GE Hitachi Nuclear Energy

NEDO-33284

Licensing Topical Report
Marathon-5S Control Rod Assembly

NEDE-33284P Revision 0 RAI Responses

Diagram of Lateral and Axial Friction Loads on the Control Rod (Control Rod Lean Exaggerated)

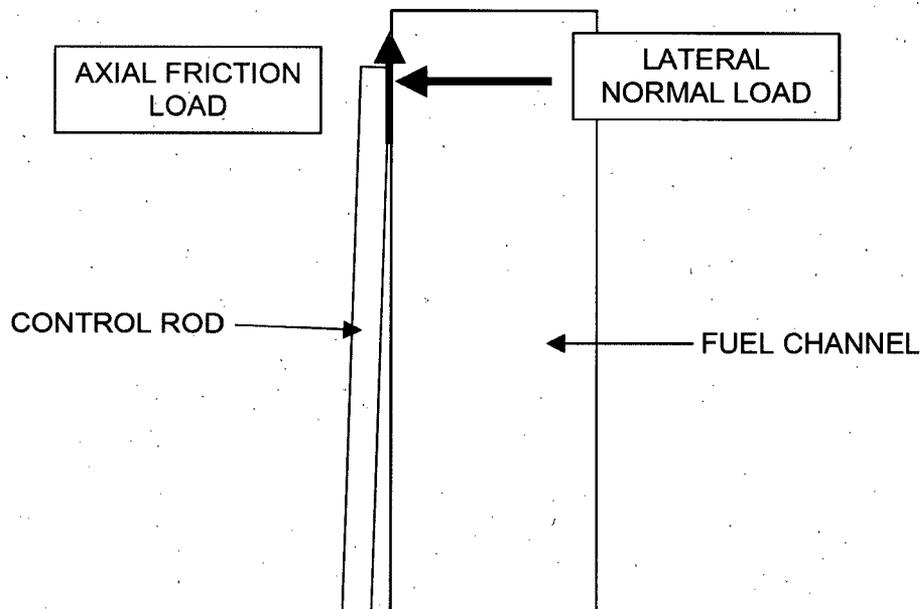
In section A-1.4, a "conservatively estimated" maximum added friction force of [[]] is stated.

a,b,c,d) Lateral loads on the handle rollers were determined during testing of alternate roller materials. The tests showed that the lateral loads on the rollers were small, typically between [[]], with a maximum of [[]]. To determine the axial friction load at this contact, the lateral load is multiplied by a friction coefficient between stainless steel and zircaloy (fuel channels) of [[]] (see Figure below). This results in a maximum axial friction load of [[]]. For conservatism, this load is rounded up to [[]].

RAI #21

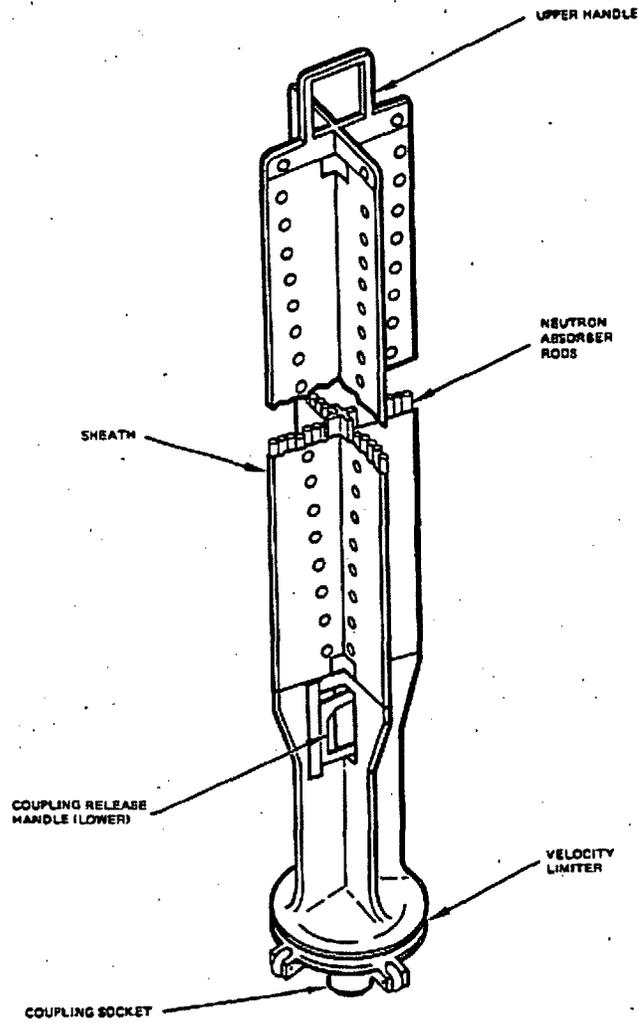
In section 2.2 there is a discussion which indicates that due to the new capsule dimensions, there is slightly less B₄C powder mass in each capsule (a trade-off to increase mechanical lifetime). In Tables 4-5, 4-6, and 4-7 there is an increase in initial reactivity worths listed (except for cold conditions in the S lattice).

- a. Please discuss how the initial reactivity worth was increased while decreasing the amount of B₄C contained in each capsule.
- b. Please provide either a brief description of the OE equipment and/or reference, to further clarify the nuclear calculations, which compares OE and Marathon-5S initial reactivity worths. This is needed to verify that the MCNP input deck geometries are correct. In particular, dimensions for the sheath, the stainless steel block in the middle of the CRB wing, and the absorber rods as modeled in MCNP should be provided.
